City of Tukwila

Staff Report Board of Architectural Review for Vietnamese Martyrs Expansion Prepared for the October 25, 2018 Meeting

FILE NUMBERS: L18-0026 Design Review L18-0027 Conditional Use Permit **APPLICANT:** Sean Hill of Broderick Architects on behalf of Vietnamese Martyrs Parish **REQUEST:** The applicant proposes a 7,000 sf² addition to an existing office building to create a learning center, partial demolition of and construction of an addition to the main church building (67,500 sf²), and related improvements including restriping and expanding the parking lot and interior remodeling. LOCATION: 6841 and 6847 S. 180th St. Tukwila, WA COMPREHENSIVE PLAN AND ZONING Tukwila Urban Center- Workplace (TUC-WP) with portions of Public Recreation Overlay A Determination of Non-Significance (DNS) was issued on SEPA DETERMINATION: October 17th, 2018. NOTIFICATION: A Notice of Application was mailed on May 11, 2018 to property owners within 500' of the site and agencies with jurisdiction and was also posted on site. Comments were received from the Muckleshoot Indian Tribe. A Determination of Non-Significance was issued on October 17th, 2018. A Notice of Hearing was mailed on Octo

Figure 5. Proposed site plan showing pedestrian pathways

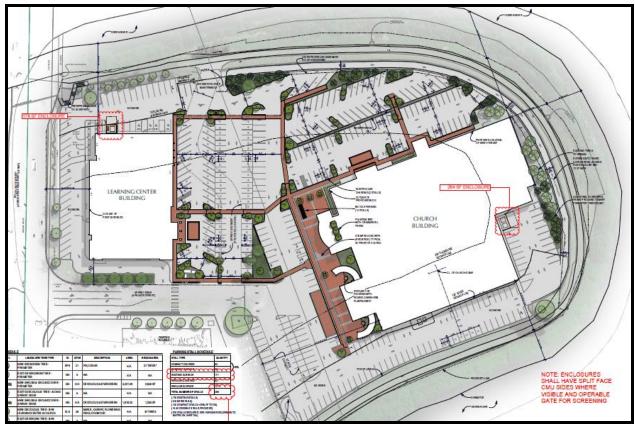
Vehicular and pedestrian circulation will be improved with project approval. The existing parking areas are devoid of landscaping islands, integrated site lighting, and pedestrian pathways. Vehicular circulation will be improved via the paving of an existing gravel pathway following the levee berm around the southern and eastern edges of the development area, marked and defined drive aisles and clear traffic patterns, and shielded, directed parking lot lighting. The expanded parking lot areas meet all landscaping and lighting requirements and feature 6' wide pedestrian paths to the buildings easily identifiable by colored pervious pavement and framed by pedestrian lighting fixtures. The section of pedestrian pathway adjacent to the Learning Center's southern wall from Sperry Drive to the trail will be accessible to the public via a recorded public access easement, marked with appropriate signage, and maintained for the life of the project by the applicant. When selecting a route that could be used for public shoreline access, several routes were considered including a stairway descending from the S. 180th St. bridge terminus at the northeast corner of the site down to the trail, and a sidewalk extension on the east side of Sperry Drive. The sidewalk extension on the west side of Sperry Drive, crossing over and continuing east in a straight line was selected because of problems identified with the other two options by the Flood Control District, Tukwila Parks Department, and Public Works staff. Additionally, it was noted that the large deciduous trees on the west side of Sperry Drive are lush and healthy while the trees on the east side are over pruned and struggling. The proposed public access route saves the healthy trees, improved pedestrian circulation to and throughout the site, and replaces unhealthy and struggling landscaping.

Site Requirements (TMC 18.28.280): Pedestrian pathways through the parking area have been provided to facilitate pedestrian circulation and reduce plant damage from pedestrian traffic. The pedestrian crosswalks within the parking lot shall be finished with the same pervious pavement as that used in the plaza in order to enhance pedestrian safety, comfort, and the attractiveness of the site.
